**SB-10056180-8977**

# SERVICE BULLETIN

## PATHFINDER; DISTANCE TO EMPTY MILEAGE ERRATIC BEHAVIOR

**APPLIED VEHICLES:** 2013 - 2014 Pathfinder (R52)  
2014 Pathfinder Hybrid (R52)

Figure 1

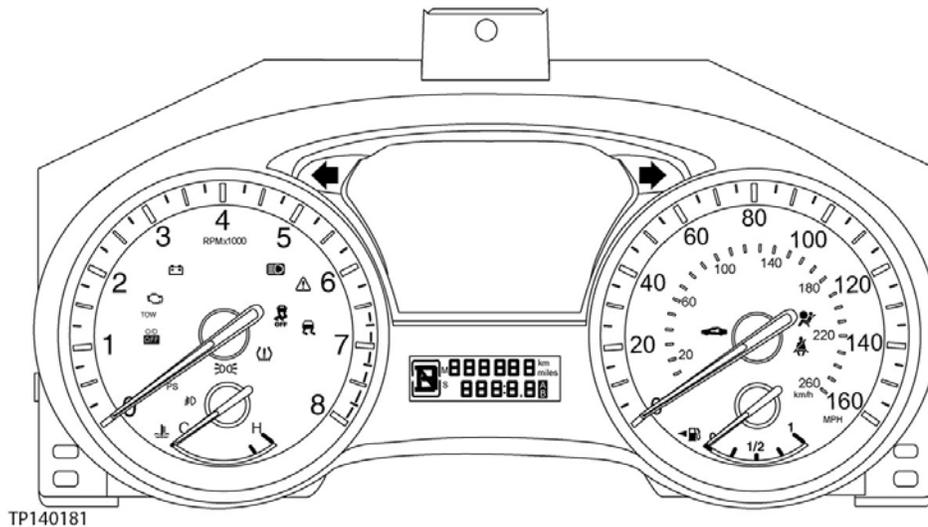
If the customer states the mileage displayed for Distance To Empty (DTE) changes abruptly or unexpectedly, up or down.

- The customer may also describe the issue as DTE mileage does not match or “agree with” the fuel gauge reading for example, DTE shows 175 miles while the fuel gauge shows ¼ full.

Replace the combination meter assembly.

- Refer to the Electronic Service Manual (ESM), section **MWI-Meter, Warning Lamp & Indicator**, for replacement information.
